Road Safety Audit Review

VT 15 & I-89 Exit 15 NB City of Winooski

April 6, 2006

Road Safety Audit Review Review Report

Figure 5. Major Crash Patterns for the 2001-2004 Reporting Period

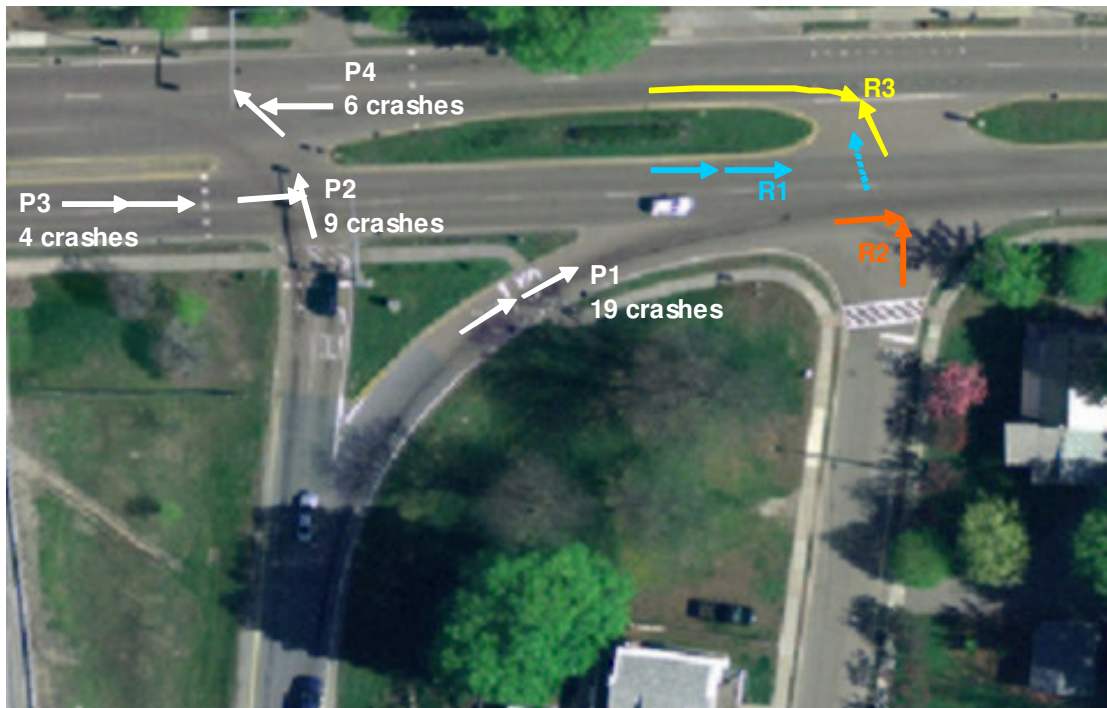
The pattern with the most crashes (P1 in Figure 5) took place at the slip lane. In this case, motorists rear-ended each other as a result of the first car stopped at the stop sign moving and stopping again and the motorist behind thinking that the car in front was gone.

R1: Rear-end; Time 0715; VT 15 vehicle stopped to let a car out of Roland Ct.

R2: Right-angle; Time 0559; Motorist out of Roland Ct did not observe any traffic on VT 15, made left turn.

R3: Head-on; Time 0715; Resident came out of drive at 363 E, went EB in WB lane to reach the median opening.

The second pattern with the most crashes (P2) took place on the eastbound approach on VT 15. On this approach, people were involved in right-angle crashes due to red light running on VT 15. In the crash report narratives, some of the motorists involved said that the sun was shining on the signal lenses and that they could not tell the color of the traffic lights. Some others simply stated that the lights went from green to yellow.

Still on the eastbound approach, a less important pattern (P3) consists of rear-end crashes in which the front vehicle stopped for the change of lights.

In the westbound direction, right-angle crashes at the intersection are also taking place (P4). As was the case for pattern P2, these crashes are due to red light running. In the narratives of the crash reports, a couple of motorists indicated that they had failed to notice the color of the light or that it was red. For the other crashes, the reason was not stated.

Another somewhat recognizable pattern is the one with rear-end crashes in the deceleration lane (P5). In this instance, somebody was usually rear-ending another vehicle as a result of the vehicle at fault driving too fast to stop in time. There were two such crashes during the four-year period (at least another one was recorded for 2005).

In addition to the five patterns described above, a review of the crash data near the intersection of Roland Court indicated that three crashes had taken place at this intersection during the four-year period (referred to as R1, R2 and R3 in Figure 5). All three crashes took place before 7:30 am and all three crashes involved or were caused by a left turning vehicle out of Roland Court.
